EDGEWATER REDEVELOPMENT

REVISED SUBMITTAL PACKAGE LANDMARKS COMMISSION

RE: UPDATED LANDMARKS SUBMITTAL PACKAGE FOR EDGEWATER HOTEL REDEVELOPMENT, 666 WISCONSIN AVENUE, MADISON, WI 53703

Figure 1.3 Previous Lakefront Elevation as Compared to Revised Lakefront Elevation

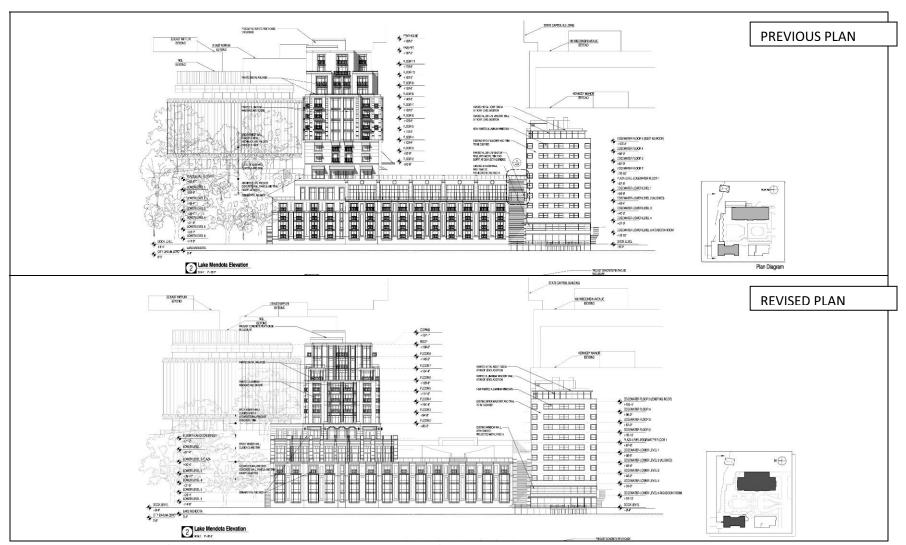
Reduced Height By 3 Stories / 30 Feet

The proposed expansion tower has been reduced by 3 stories and a total of 30 feet in height. The last occupied floor of the expansion tower has been lowered from 187'-2" (the Capitol Height Limit) to 157'-1" which is equivalent to the height of the last occupied floor of the adjacent National Guardian Life building. Figure 1.3 illustrates the height of the proposed tower in relation to the previously proposed design.

The revised plan has reduced the size and profile of the penthouse structure. The height of the penthouse no longer penetrates the Capitol Height Limit and will not require the additional approval for a Conditional Use Permit.

Figure 1.5 Sectional Comparison Existing vs. Revised

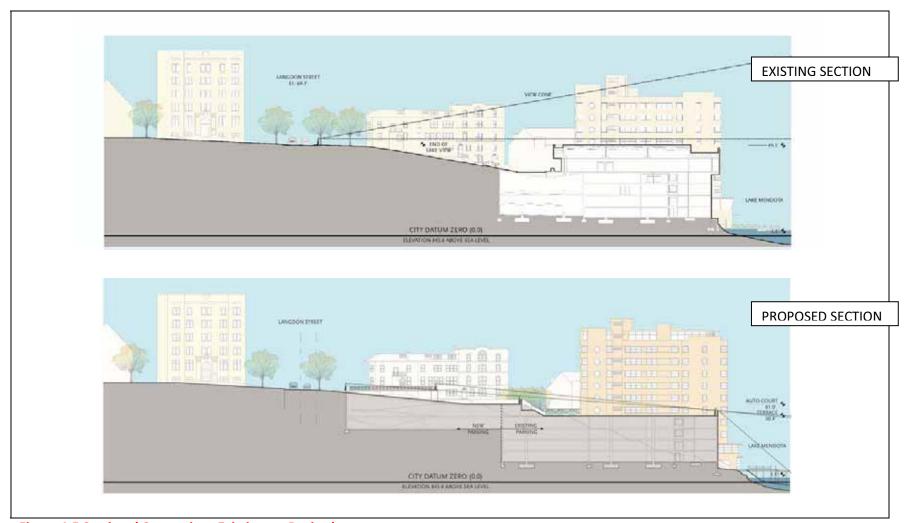
Removed Top Level of 1970's Expansion / Height and Volume Reduction in Right-of-Way Landmark has proposed to remove the top level (20+ feet) of height and 295,000 cubic feet of volume from the 1970's expansion which was built in the vacated Wisconsin Avenue right-of-way. This change will not only result in an enhanced terrace and public space at the water, but will also restore one of Madison's most important street-end views.

This change has significant impacts for the public view from the street to the lake and from the lake back to the State Capitol. Additionally, the removal of this existing structure will transform this corridor from a solid structure to an open, active public terrace at the lakefront. Figure 1.5 provides a sectional illustration of the existing and proposed conditions for the terrace.
